DNDEN00035A

2865 AKERS DRIVE

CONSTRUCTION DOCUMENTS

DISH Wireless L.L.C.
 PROJECT INFORMATION
 DNDEN00035A
 ELSMERE CO 1
 2865 AKERS DRIVE
 COLORADO SPRINGS, CO 80922-1520

SHEET NUMBER
T-1

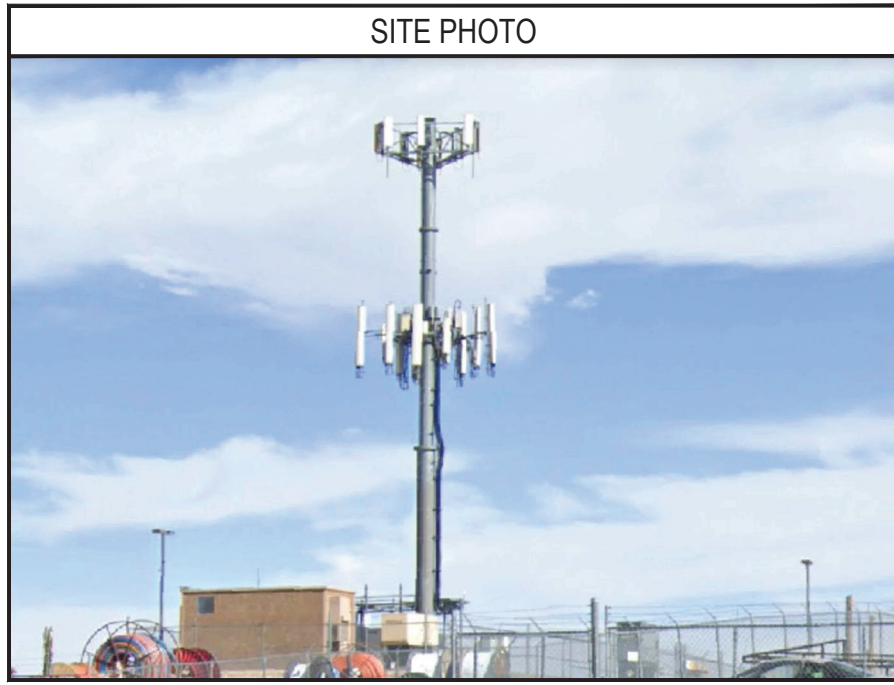
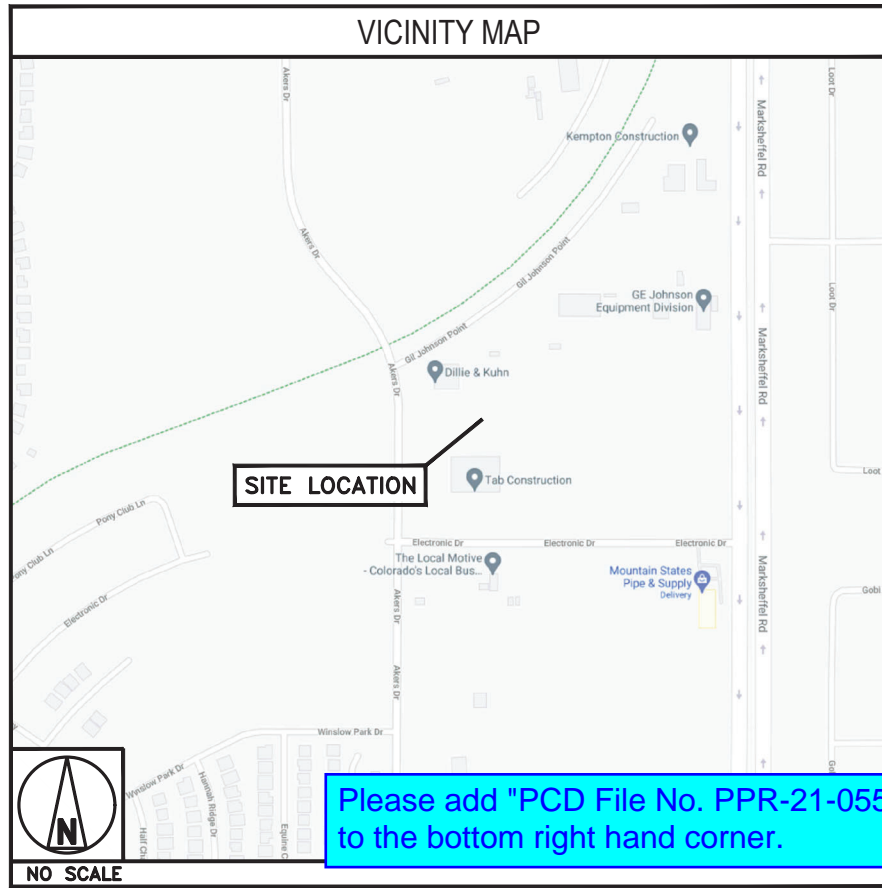
Applicant information does not match the application.

Please add "PCD File No. PPR-21-055" to the bottom right hand corner.

SHEET NUMBER
A-0

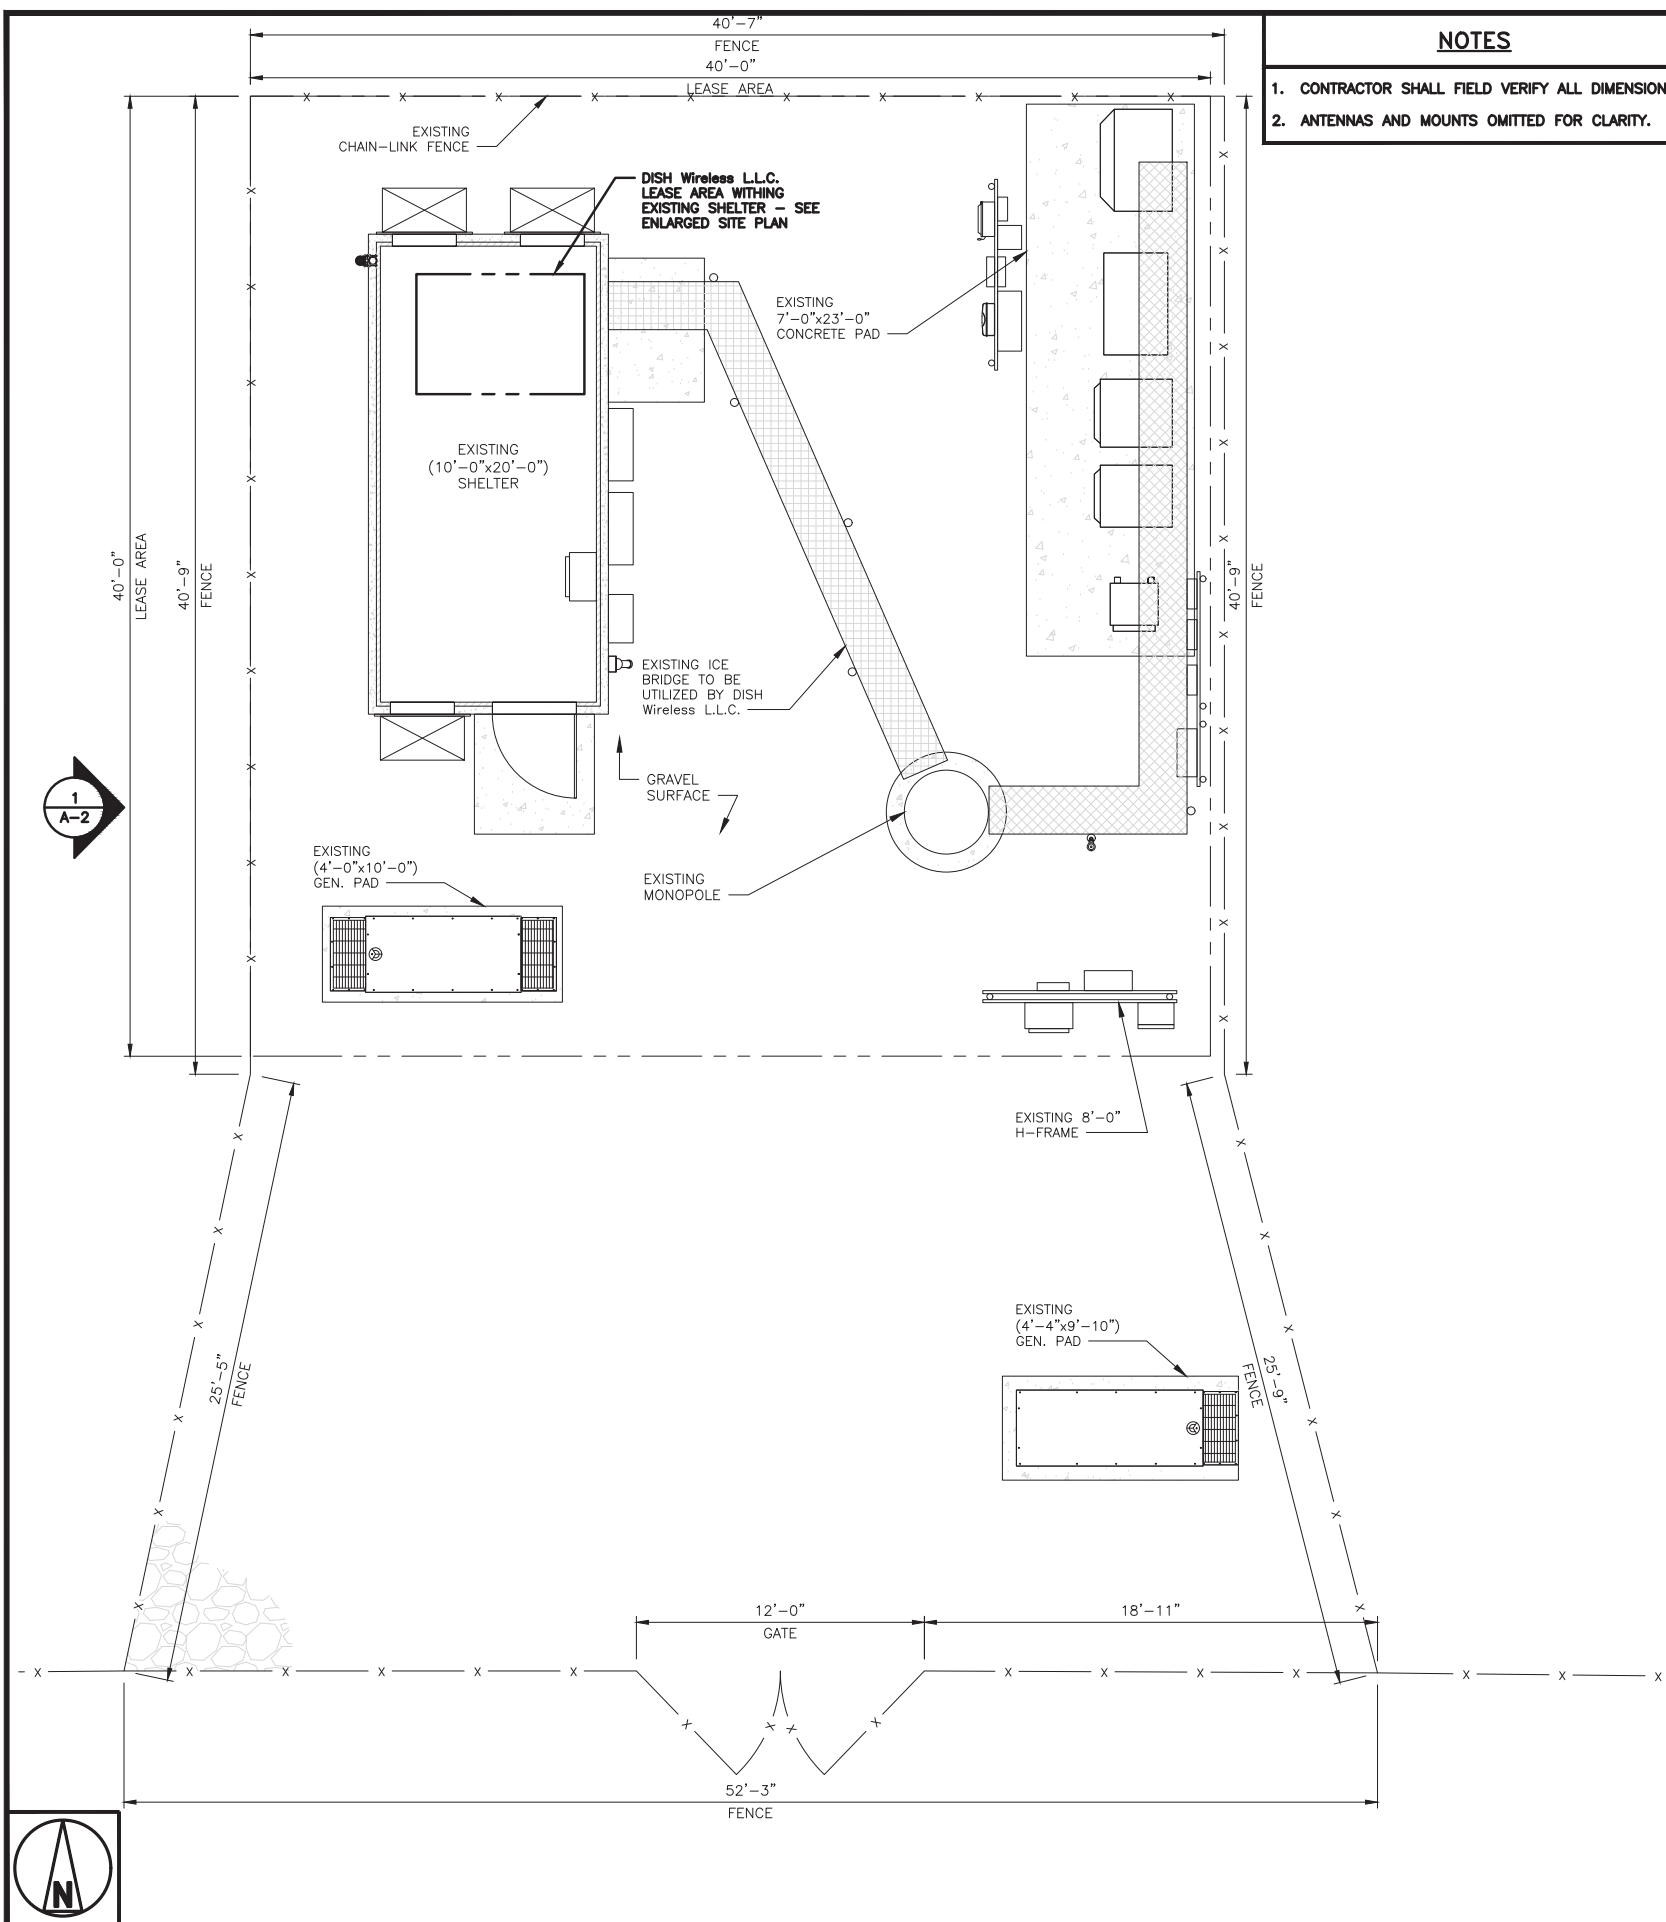
Please include the following:
 -Date, north arrow, and a graphic scale
 -Location and dimension of the all property lines, rights-of-way, and all existing and proposed easements
 -The footprint of all existing and proposed buildings and the setback distances from each existing and proposed structure to the property lines
